PRODUCT CHANGE NOTIFICATION (PCN)

AMJE0909-0030-RDB-24
MODULAR CABLE

CHANGE NOTIFICATION: PCN 20220509_AMJE0909-0030-RDB-24

AMJE0909-0030-RDB-24 OLD VERSION

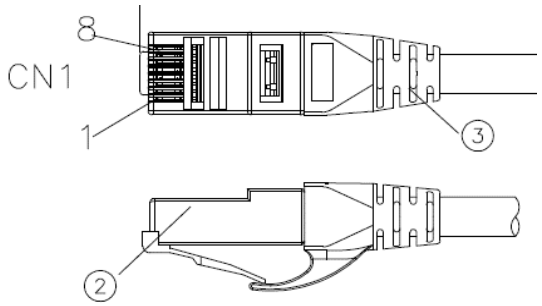
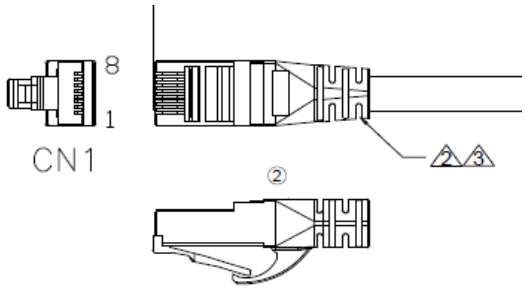
③	Molding	PVC 45P Color: see order code	NA	KG
②	CONNECTOR	RJ45 8P8C two fork Short type 3u" gold plated	2	PCS
①	CABLE	CAT6 UTP (24AWG*1PR)*4+PVC OD=5.8±0.3MM Color: see order code	NA	MM
NO:	NAME	DESCRIPTION	Q'TY	UNIT

3	Molding	PVC 65P Color: see order code ②	NA	KG
2	CONNECTOR	RJ45 8P8C PLUG 3u" gold plated ②	2	PCS
1	CABLE	CAT6 U/UTP (24AWG*1PR)*4+Cross+PVC Jacket OD=5.8± 0.3MM Color: see order code ②	NA	MM
NO:	NAME	DESCRIPTION	Q'TY	UNIT

Drawing-No.
ASS 7945 CA

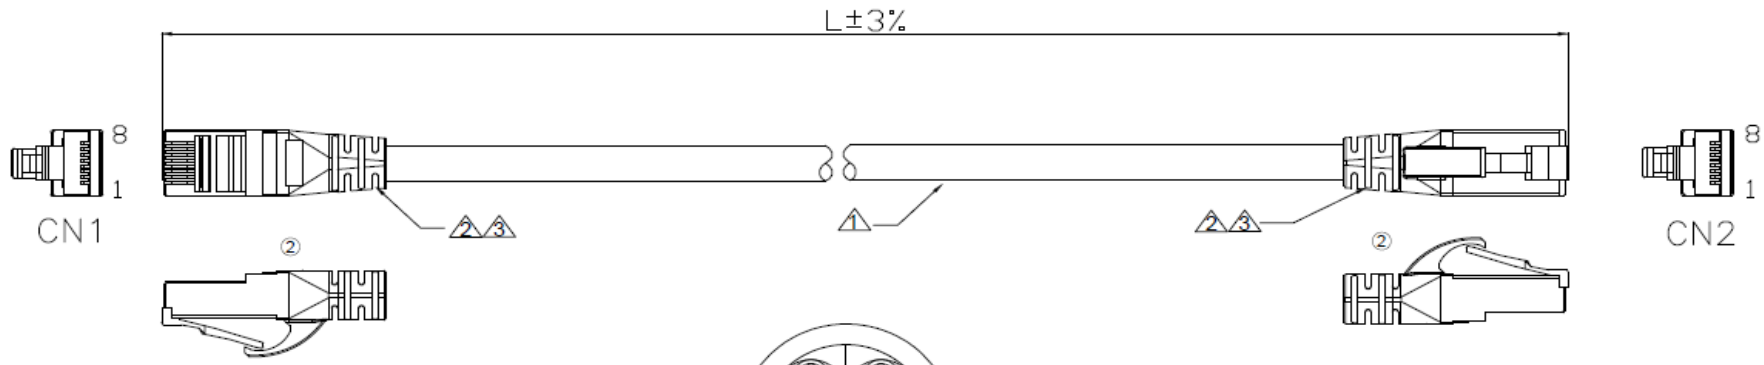
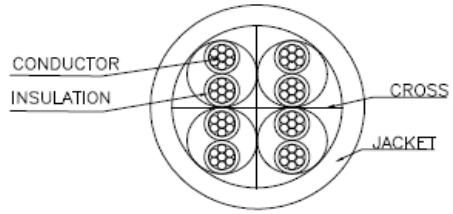
Id.	Modification	Date	Name
②	Change the plant	09.05.2022	Luca
①	Update the WSW order code	02.06.2017	Amy
⓪	Drawn	30.03.2017	Amy

NO:	NAME	DESCRIPTION	Q'TY	UNIT
3	Molding	PVC 65P Color: see order code ②	NA	KG
2	CONNECTOR	RJ45 8P8C PLUG 3u" gold plated ②	2	PCS
1	CABLE	CAT6 U/UTP (24AWG*1PR)*4+Cross+PVC Jacket OD=5.8± 0.3MM Color: see order code ②	NA	MM
